Bid Package 02 - Construction Bulletin 01

**Canadian County Expo Center
3001 Jensen Road East
El Reno, OK 73036**

The work shall be carried out in accordance with the following supplemental instructions issued in accordance with the contract documents without change in contract sum or contract time. Prior to proceeding in accordance with these instructions, indicate your acceptance of these instructions for minor change to the work as consistent with the contract documents and return a copy to the architect.

C7-0

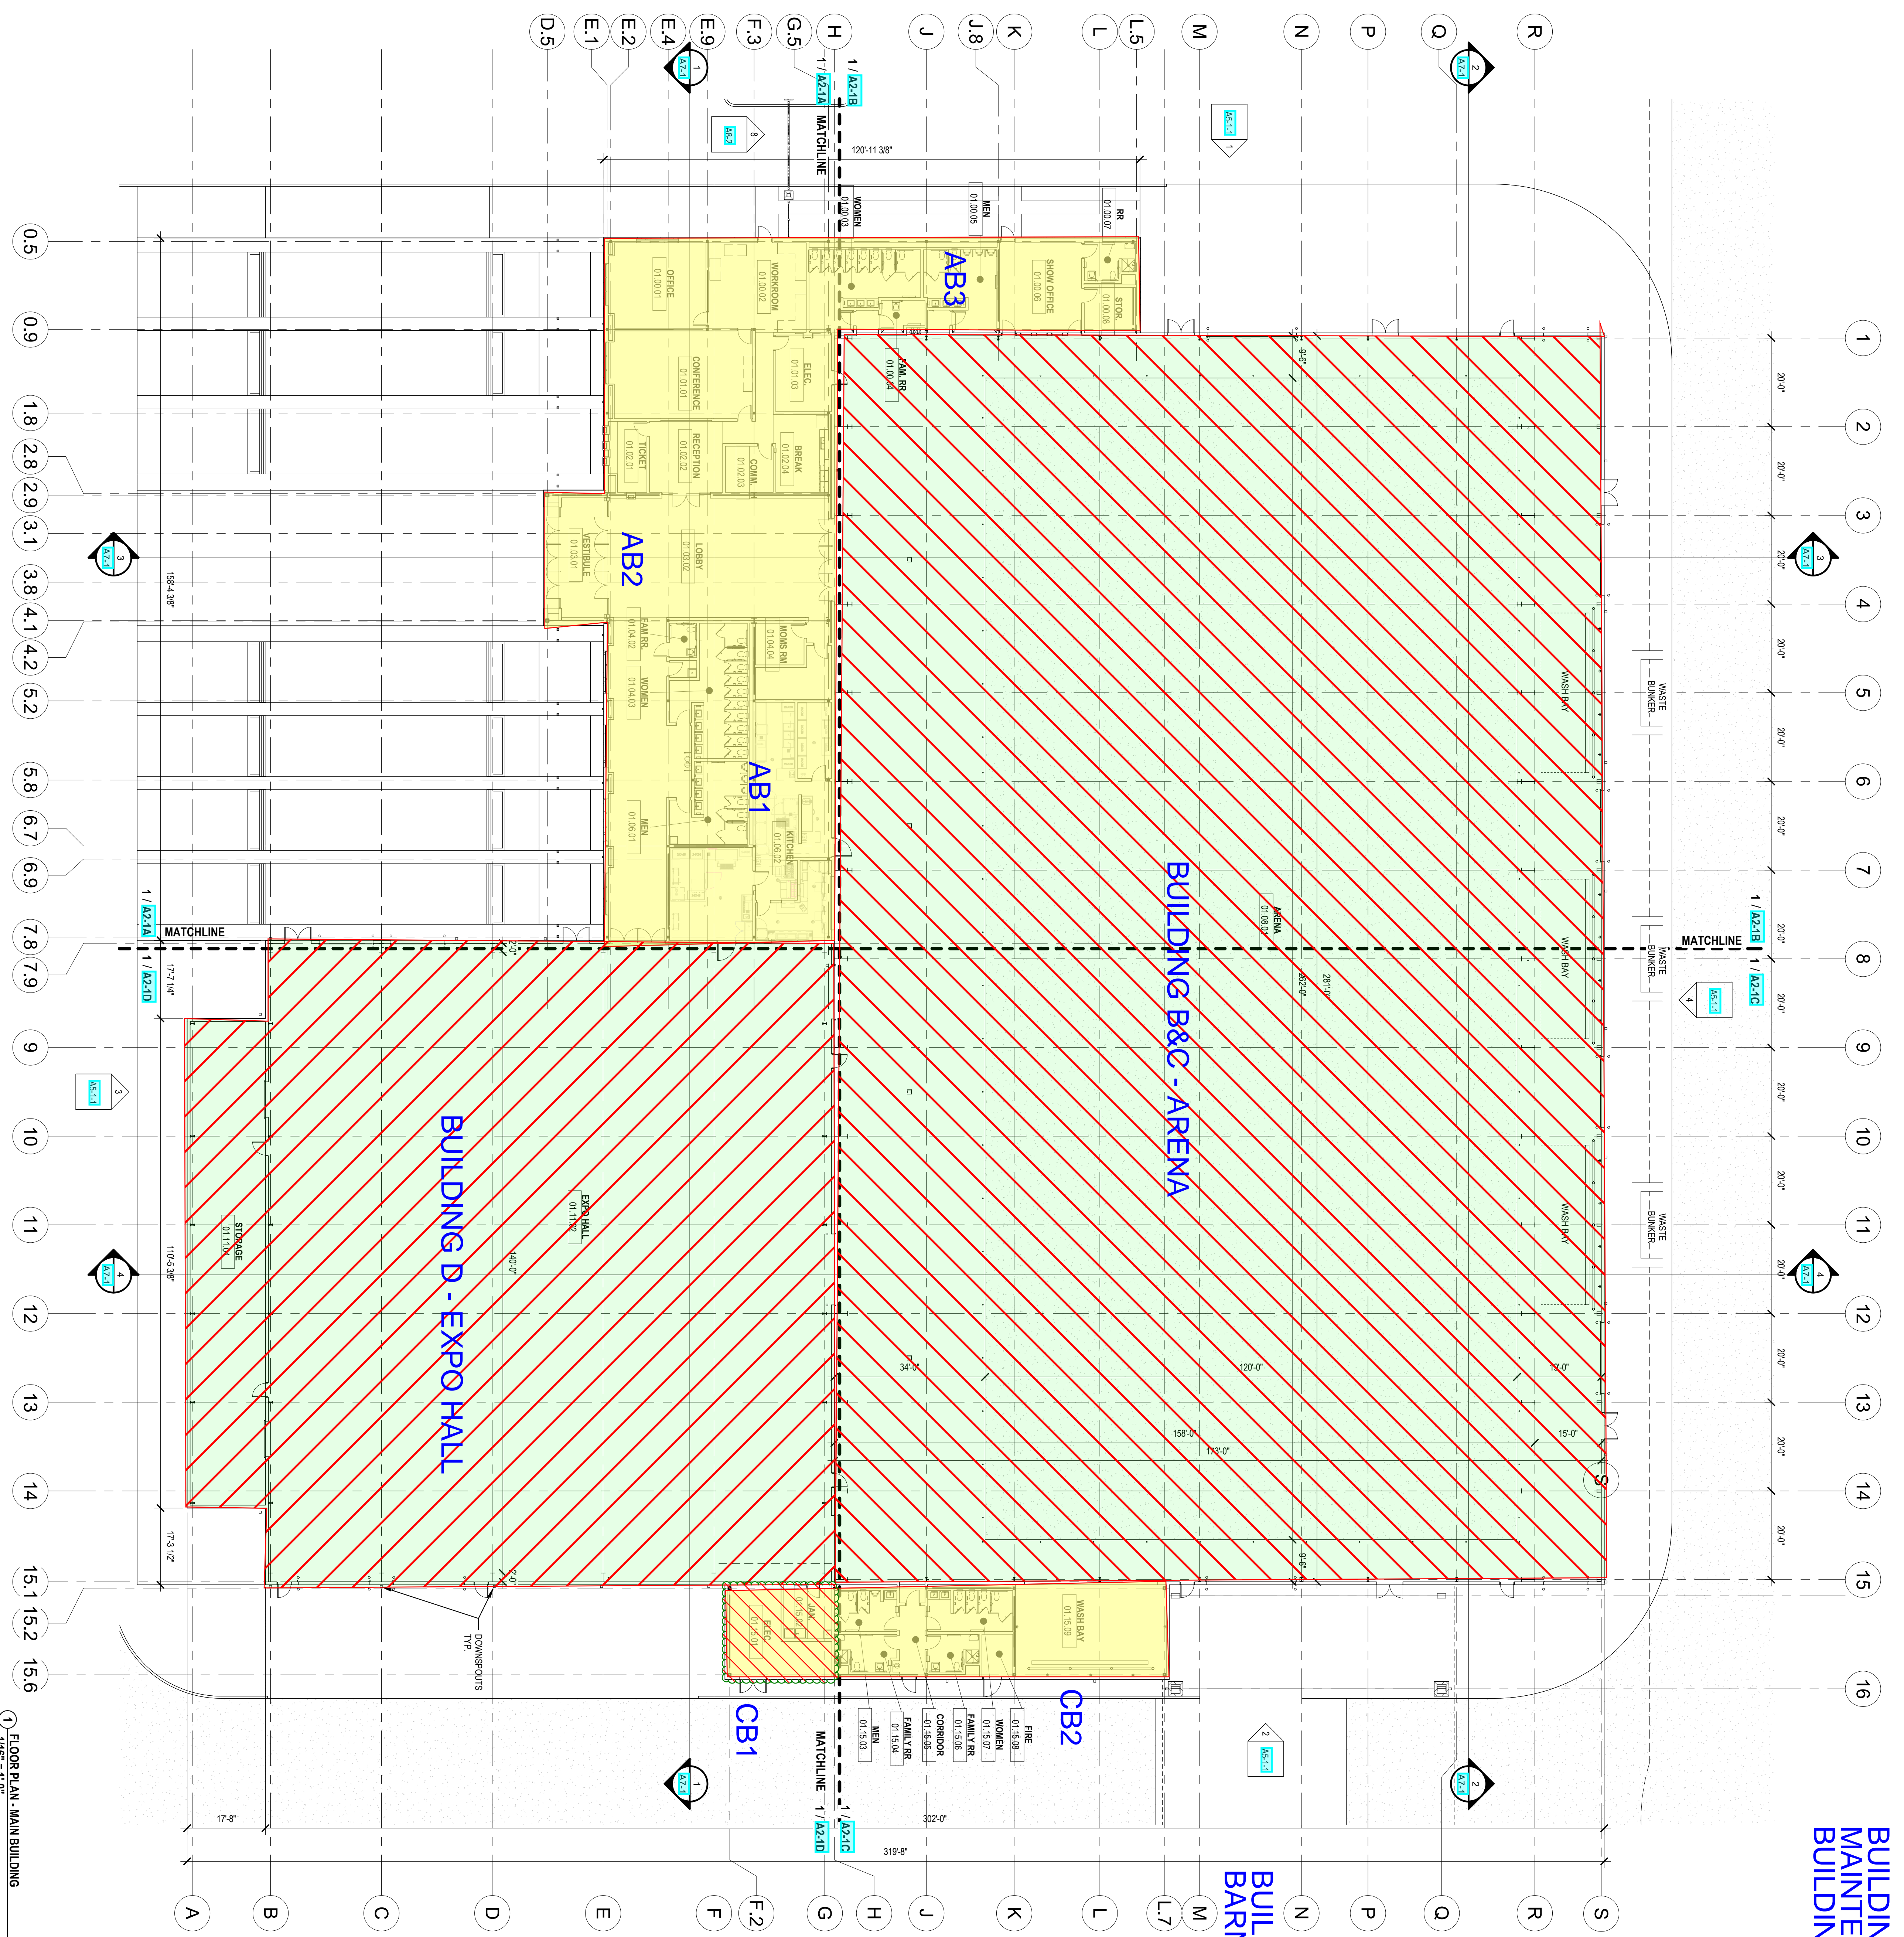
- 6" waterline callout changed to 12" waterline
- C7-0 Overall Utility Plan
 - The 4" domestic water line was changed to a 3" line.
 - Changed the 1" maintenance building meter to a 2" meter

- Added a 4" sanitary sewer connection for the Stall Barn at the SW corner.
 - Changed the 12" line from the east side of the Expo to an 8" water line south and east of the Stall Barn to the FH.

- Added 8" gate valves near the FH assembly north of the Stall Barn
 - Changed the 12" plug to an 8" plug
 - Revised the 12" x 6" tee to an 8"x6" tee.
 - Storm Line 2 (15" Class IV RCP) was changed to 18" Class IV RCP.
